Point Beach Nuclear Plant, Unit 2
Docket 50-301
Renewed License No. DPR-27

10 CFR 50.55a Request, Relief Request RR-4L2
Inservice Inspection Impracticality
Examination Limitations Due to Configuration
Fourth Ten-Year Inservice Inspection Program Interval
Response to Request for Additional Information

10 CFR 50.55a REQUEST, RELIEF REQUEST RR-4L2 INSERVICE INSPECTION IMPRACTICALITY EXAMINATION LIMITATIONS DUE TO CONFIGURATION FOURTH TEN-YEAR INSERVICE INSPECTION PROGRAM INTERVAL RESPONSE TO REQUEST FOR ADDITIONAL INFORMATION

Figure 3-2. Steam Outlet Nozzle and Venturi Insert Assembly Details

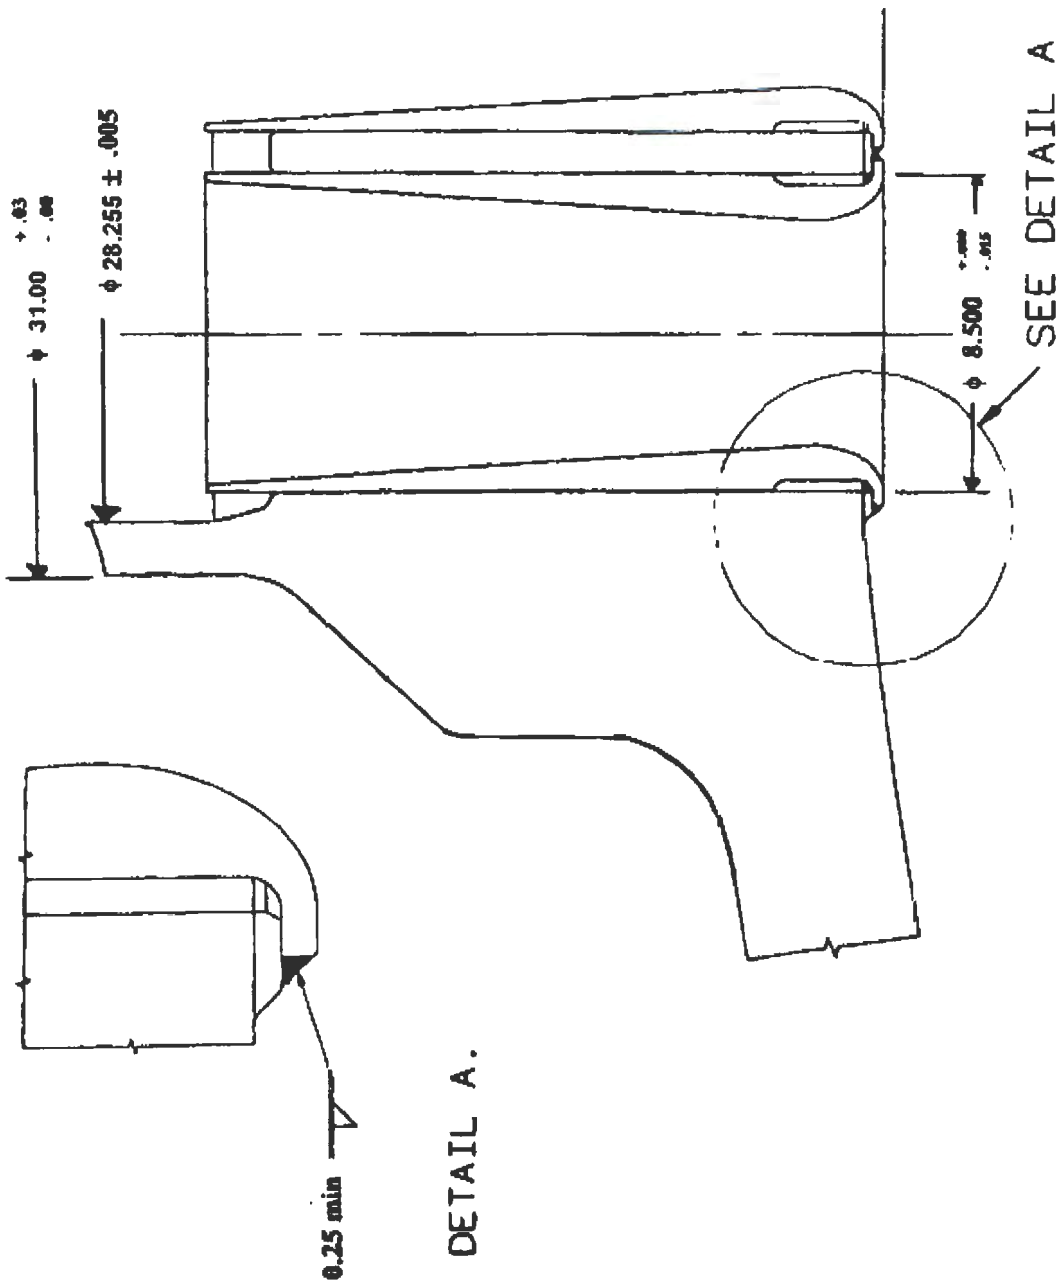
- 1. The drawing of the flow restrictor provided appears to show that the flow restrictor is constructed of clad ferritic steel, but this is not explicitly stated in the relief request. Please describe the materials of construction for the flow restrictor.*

- a. The Steam Nozzle Flow Limiter shown in Figure 4L2-1 is fabricated from the following components:

Steam Outlet Nozzle
Venturi Inserts (7)

SA-508 Class 3A
SB-564 (Inconel 690)

A 0.22" thick weld overlay of Inconel 52 was deposited on the Steam Outlet Nozzle. The Venturi Inserts are welded to this overlay with Inconel 52.

b. See below Drawing for additional details:
